Access Compliance Report Public Rights-of-Way (Curb Ramps)

Intersection ID: 13184 Main Street: S_MINT_ST Cross Street: S_MINT_ST Location: SE

ADA ID: C1BF46126F3B Ramp Type: Perp Initial Pass/Fail: Fail Overall Compliance: No Severity Score: 13.75

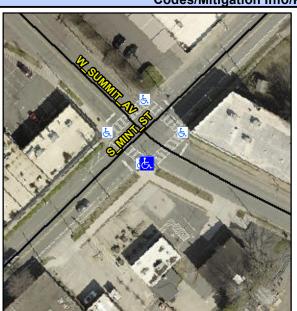
Not Found, R304.2.2, R304.5.3

Field Measurements/Component Compliance					
Compliance Description		Data	Comp	oliance Description	Data
N/A	Ramp Length (in)	94.0	No	Ramp Slope (%)	9.7
Yes	Ramp Width (in)	96.0	No	Ramp XSlope (%)	2.7
N/A	Flare Type LT	N/A	N/A	Flare Type RT	N/A
N/A	Flare Slope LT (%)	N/A	N/A	Flare Slope RT (%)	N/A
N/A	Flare Traversable LT?	N/A	N/A	Flare Traversable RT?	N/A
N/A	Landing Length (in)	N/A	N/A	DWS Provided?	N/A
N/A	Landing Width (in)	N/A	N/A	DWS Contrast?	N/A
N/A	Landing Slope (%)	N/A	N/A	DWS Length (in)	N/A
N/A	Landing X Slope (%)	N/A	N/A	DWS Full Width?	N/A
N/A	Landing Curb? (Y/N)	N/A	N/A	DWS Offset (in)	N/A
N/A	Shared Landing?	N/A			
N/A	Gutter Ponding?	N/A	N/A	Gutter Slope (%)	N/A
N/A	Gutter Lip Ht (in)	N/A	N/A	Gutter X Slope (%)	N/A
N/A	Painted X Walk1?	Yes	N/A	Painted X Walk2?	N/A
	X Walk 1 Direction	To NW		X Walk 2 Direction	N/A
N/A	X Walk 1 Width (in)	112.0	N/A	X Walk 2 Width (in)	N/A
	X Walk 1 Slope (%)	5.0		X Walk 2 Slope (%)	N/A

Remove & Replace Entire Ramp.
